Product Change Notification

Date Issued :	November 03, 2023	PCN Number :	514537
Reason for Change :	Obsolete		
Description of Change :	This notification is to inform you about the Obsolescence of parts(s) referenced in this notice. Please Refer attached replacement part list or contact your Molex Sales Engineer for additional queries related to possible replacement part(s).		
Reason for Short Notice :	Supplier Constraints		
Planned Implementation Date :	February 05, 2024		
Recommended replacement parts :	Please see the attached replacement parts list .xls file.		
Last Time Buy Date for Obsolete Parts :	November 13, 2023		
Last Time Ship Date for Obsolete Parts :	November 30, 2023

Before Picture

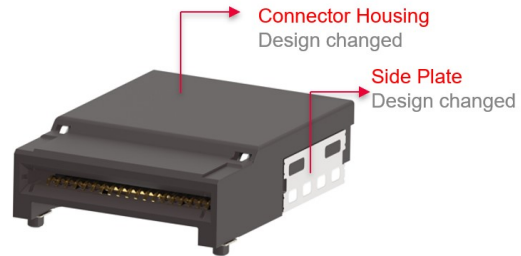
→ Tail aligner

Tail aligner is removed

- For continuous improvement, Molex will be upgrading the connector housing, side plate designs, removing the tail aligner and the material of soldering terminal is changed to gold flash for QSFP-DD 800G 1x1 connector and on account of which MPN# 2147334000 will be replaced by the new MPN# 2147336000
- Product Impact
 - Connector housing modified
 - Side plate design modified
 - Tail aligner is removed
 - Soldering terminal material is changed to Gold flash.

Old MPN	Replacement MPN	Replacement Type	Key Difference
2147334000	2147336000	Replacement with differences	Connector housing & side plate design is modified, tail aligner is removed, and soldering terminal material is changed to Gold flash.
